## **Reindeer Project Construction Services, Savoonga** EDA Project Number 07 79 07873

### **Addendum #5** 7/19/2024

Summary of items included in this addendum:

1. (Updated) List of questions received during solicitation period and answers
  - pg. 2-4
2. (Updated) Architectural Sheet A-601
  - pg. 5
3. (Updated) Structural Sheets S-101, S-102, and S-501
  - pg. 6-8

**S-501**

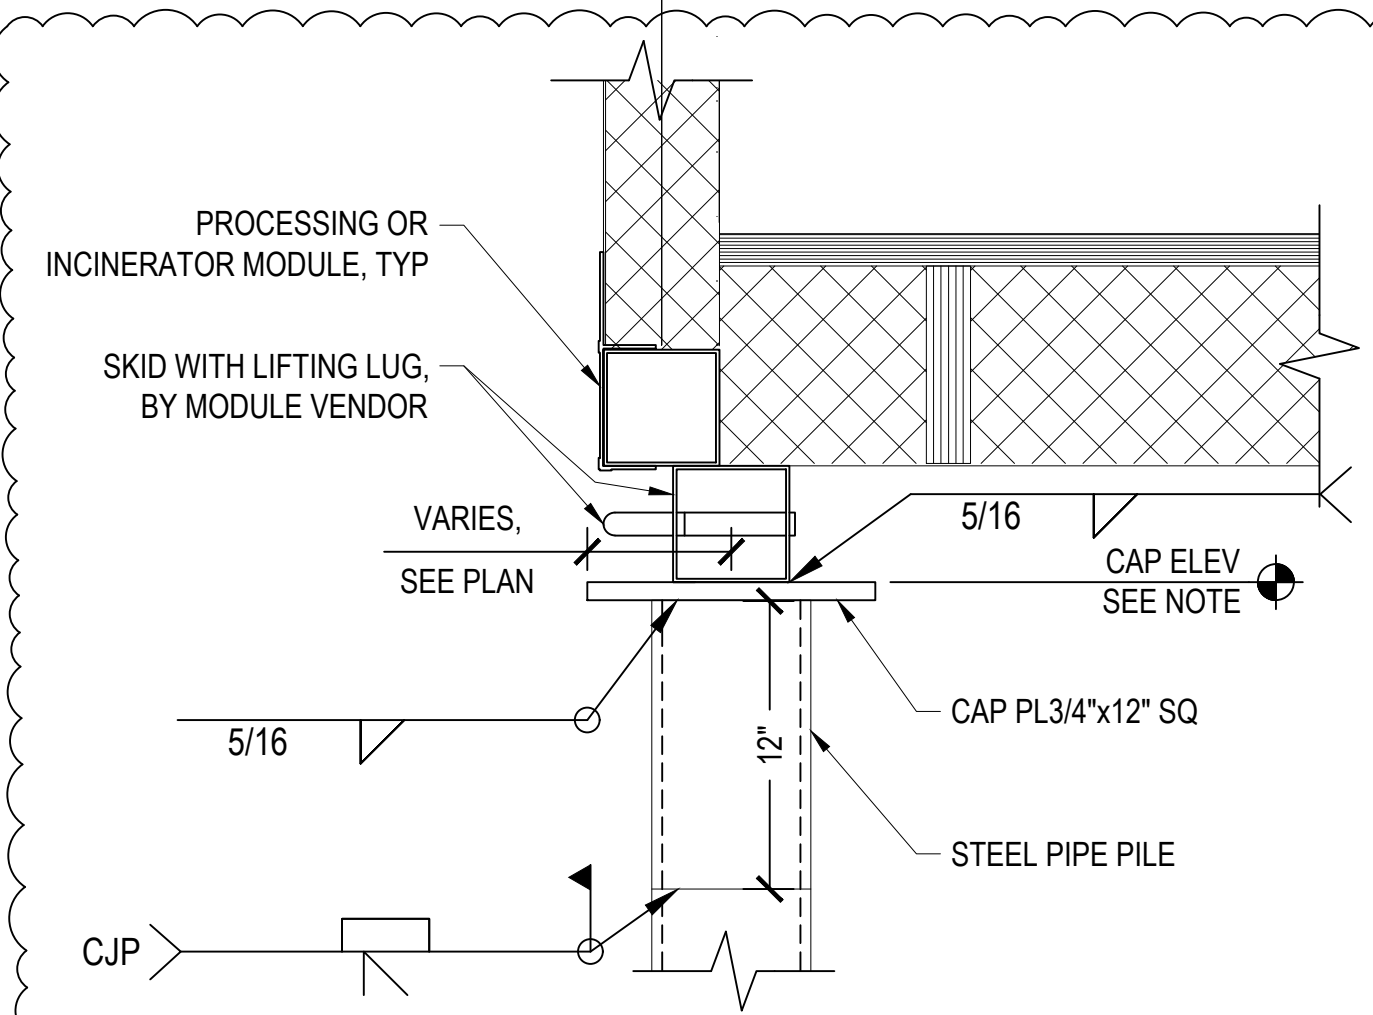
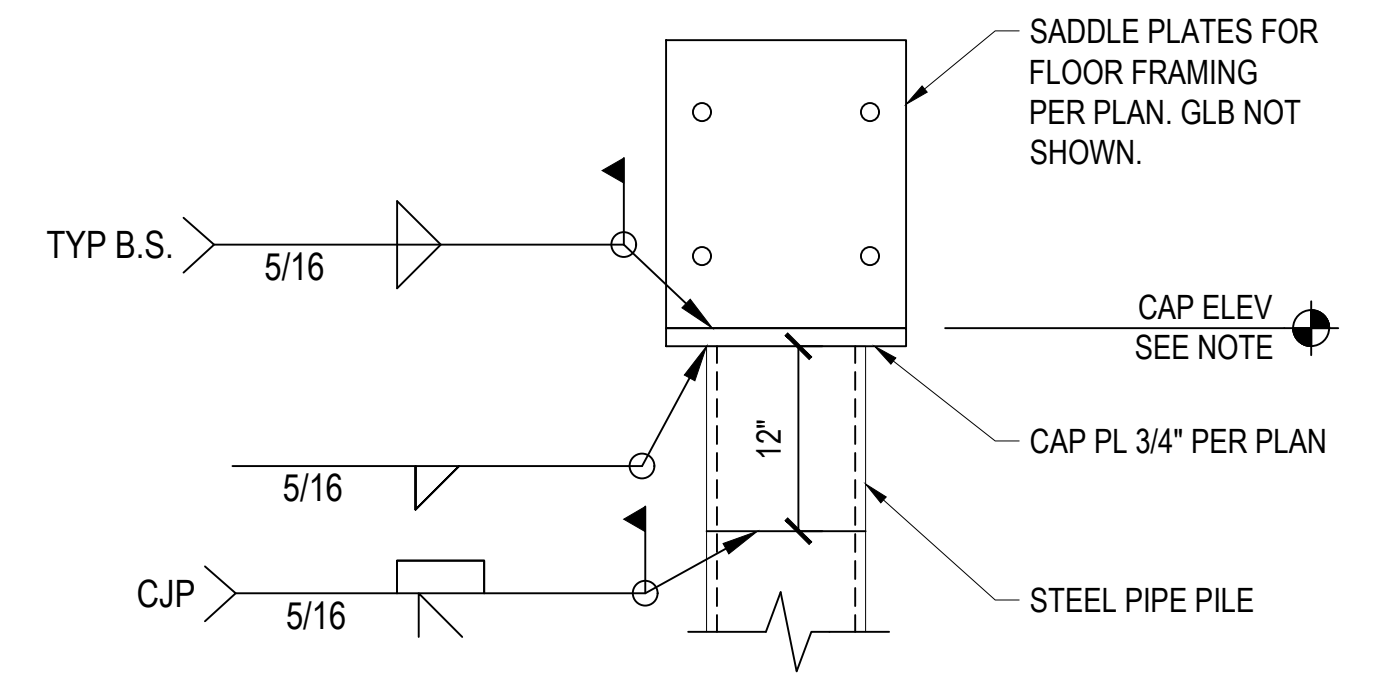
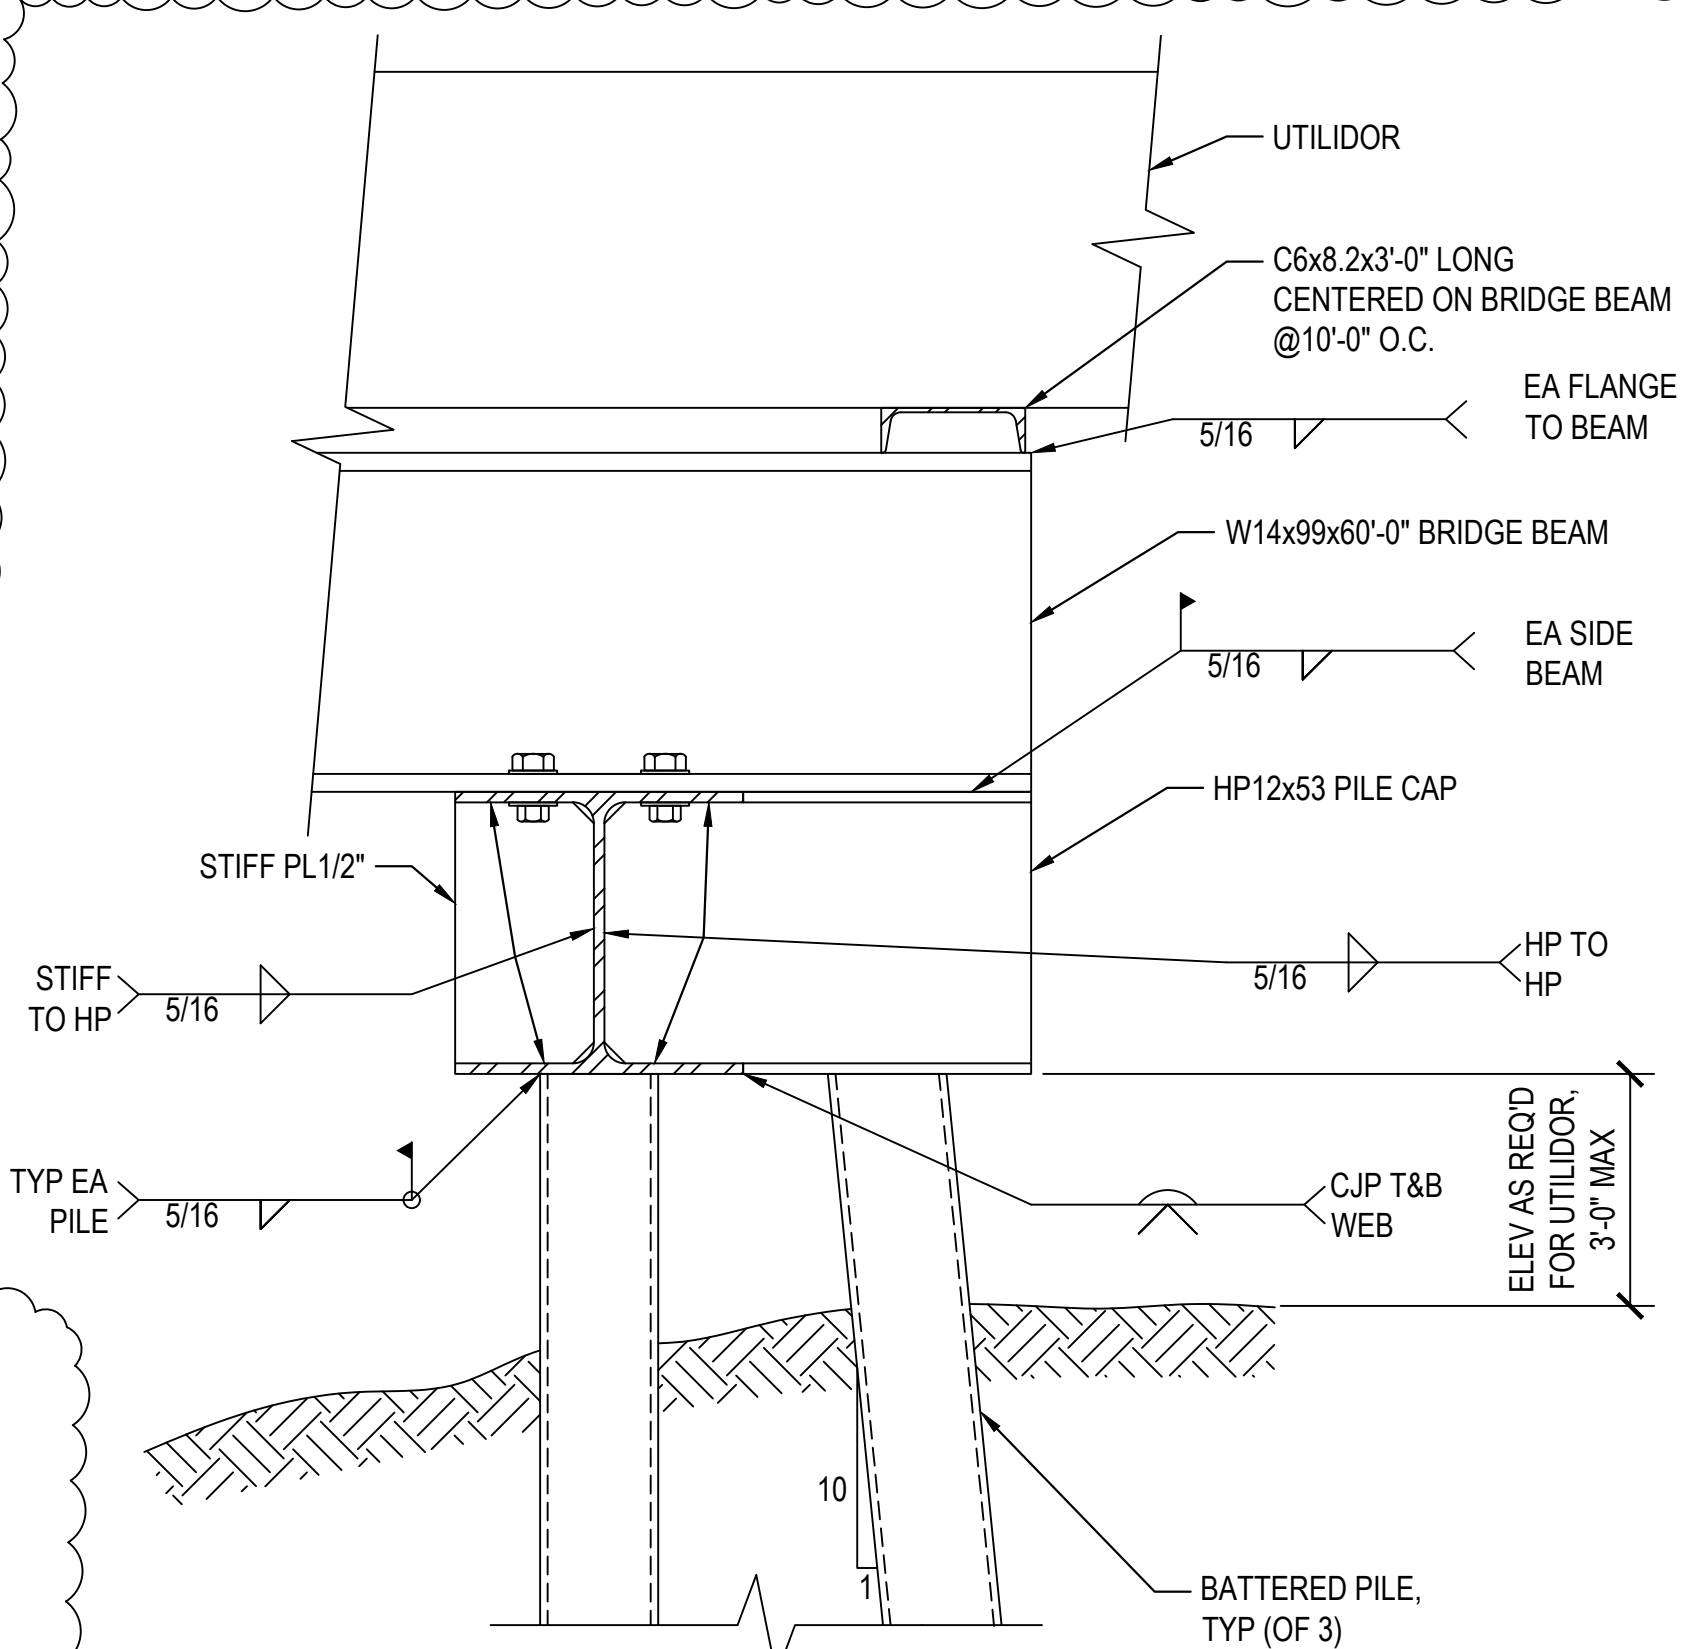
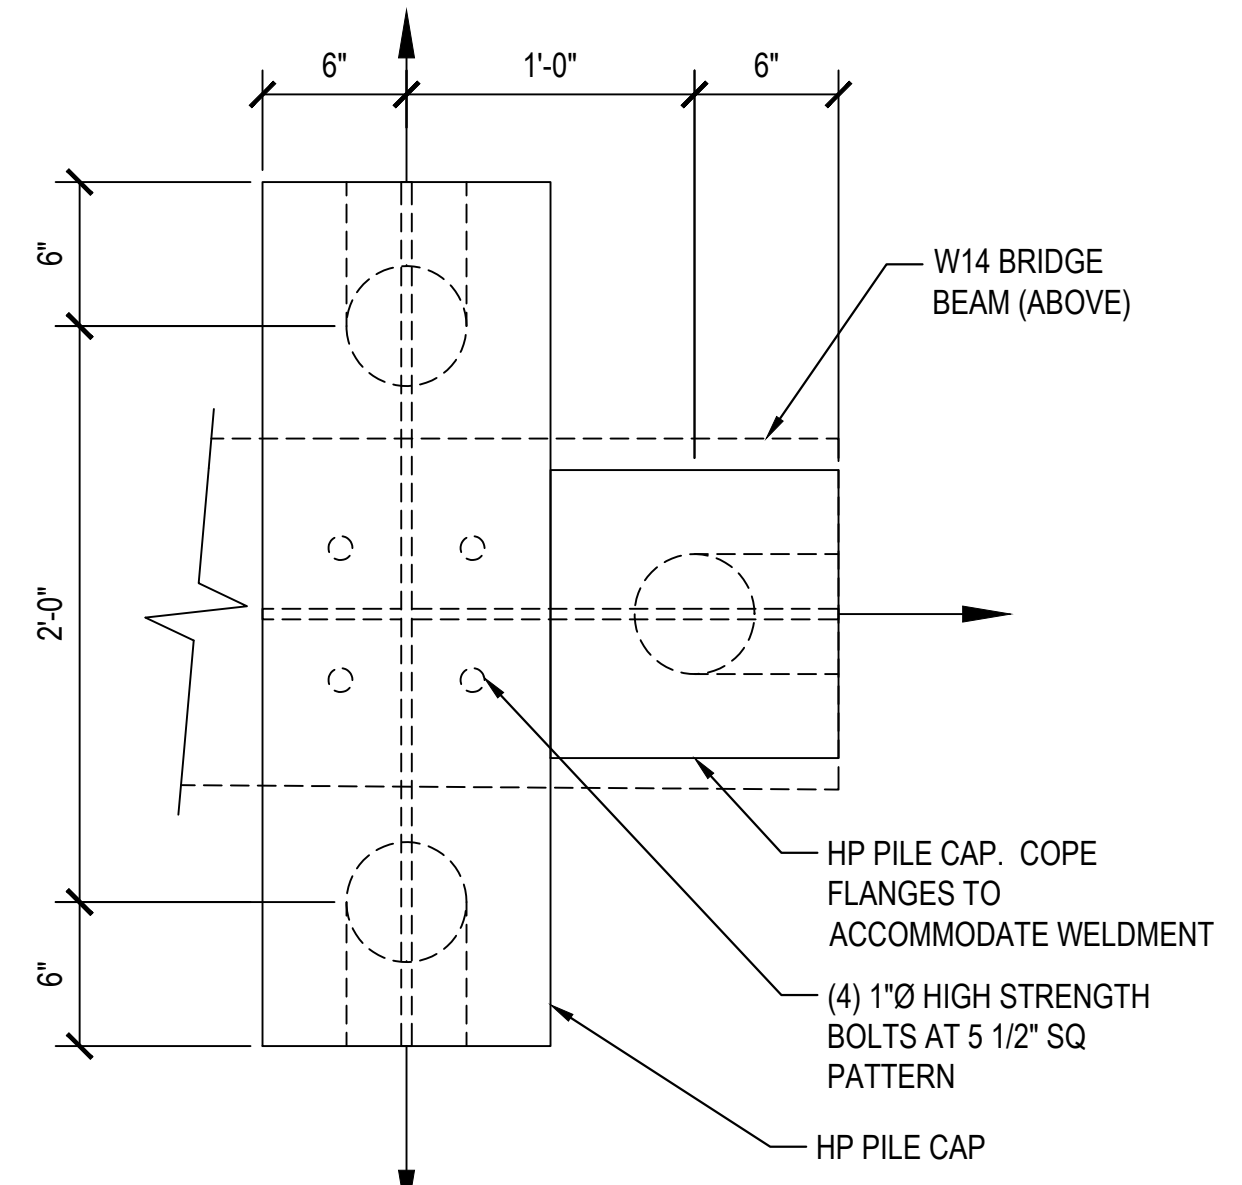
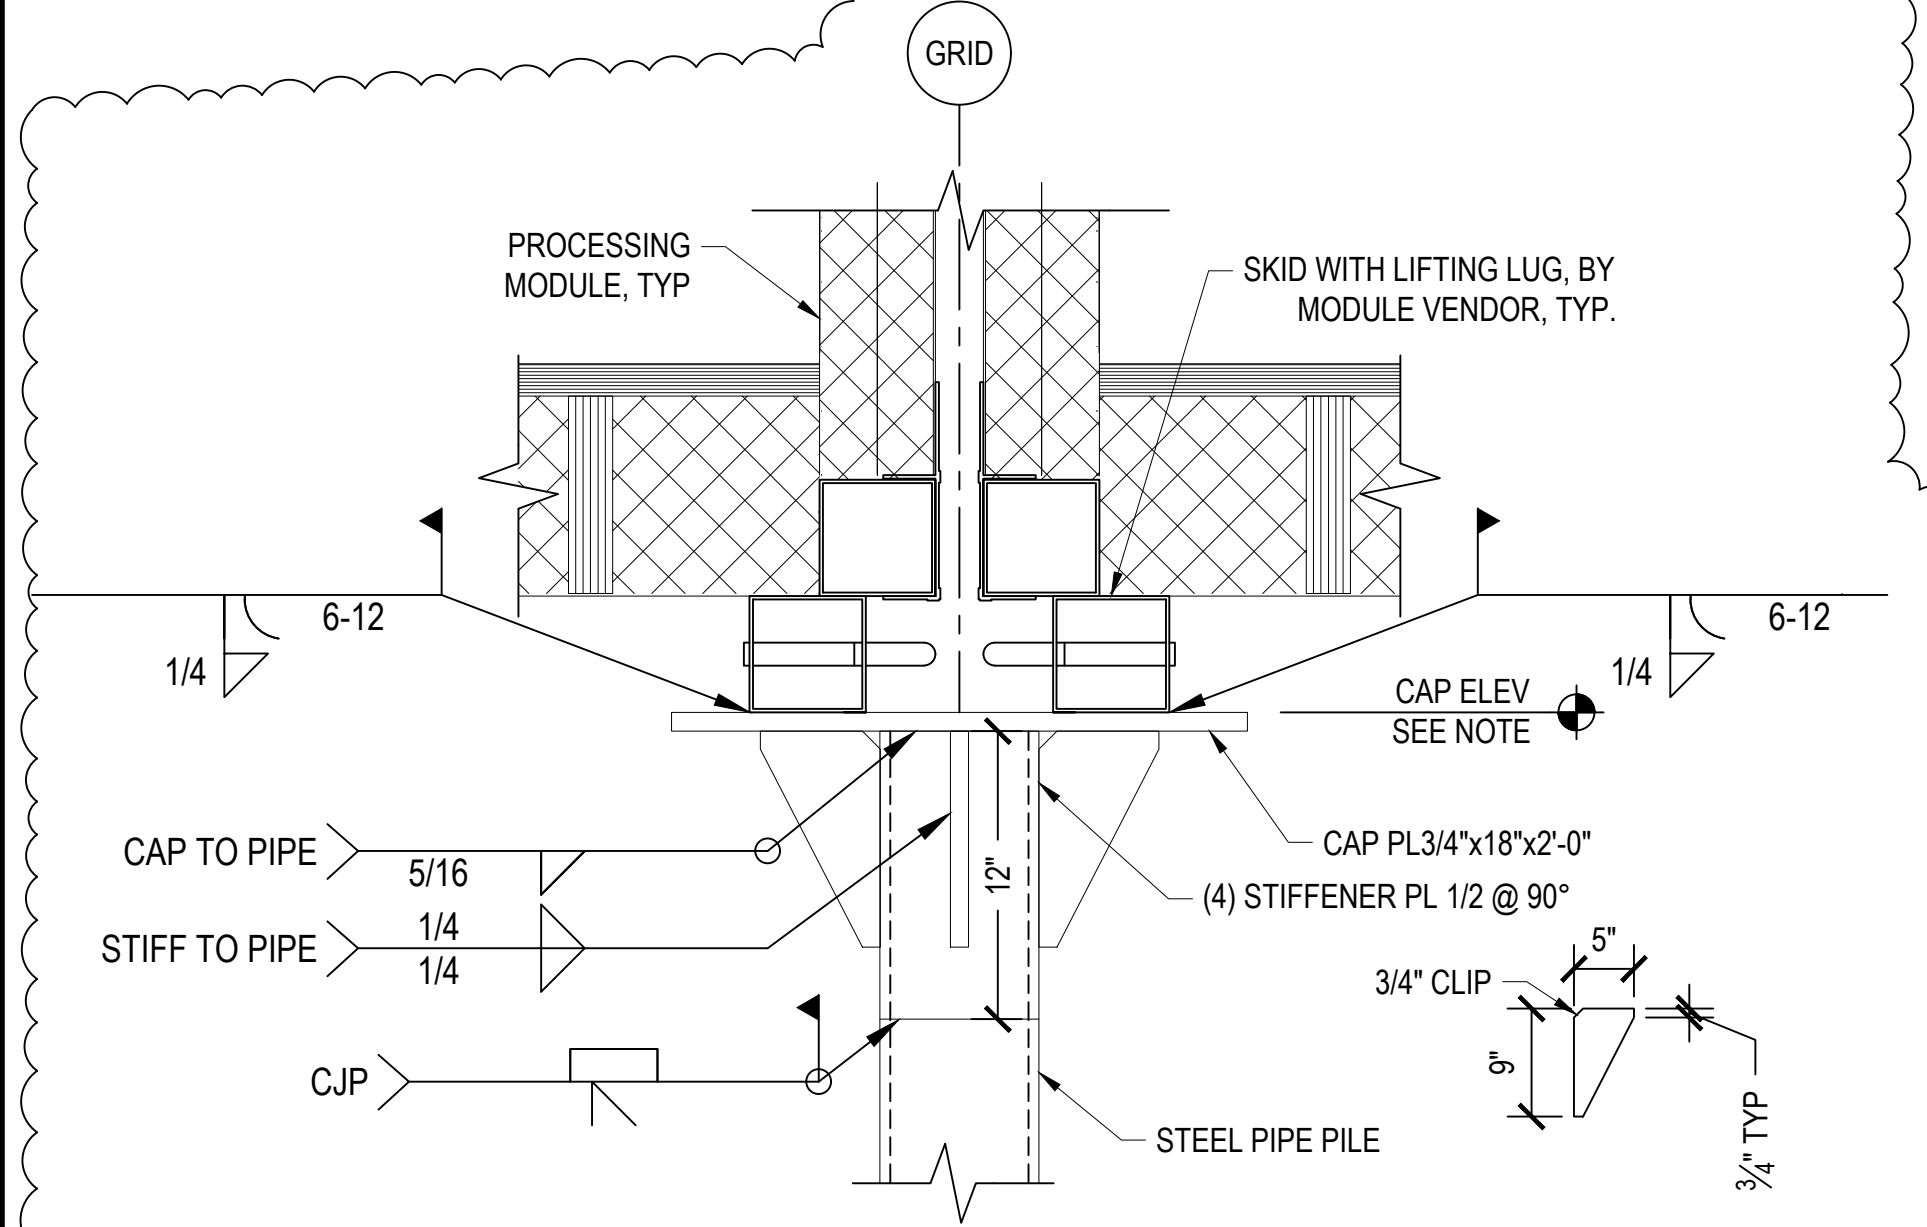
6	Please provide modular connection details. (Structural, roofing and siding details)	Refer to updated structural sheet(s), issued as part of addendum #5, for structural connection details. Refer to Exhibit A, issued as part of addendum #4, for General Contractor's involvement in roofing installation. Module exteriors are prefinished by the manufacturer and do not require siding to be installed.
7	Please confirm if the Water & Sewer Mains utilidor will be supplied and installed by others. See sheet C-200, detail 2	All water and sewer main utilidors shall be furnished and installed by the general contractor. C-200 has been updated to remove "by others" and is included in addendum #1.
8	On the Room Finish Schedule on A-601, please confirm that FRP panels are to be installed for the flooring in the bathroom.	Sheet A-601 has been revised to include clarifications to the room finish schedule and finish schedule abbreviations. The revised A-601 sheet is included in addendum #1.
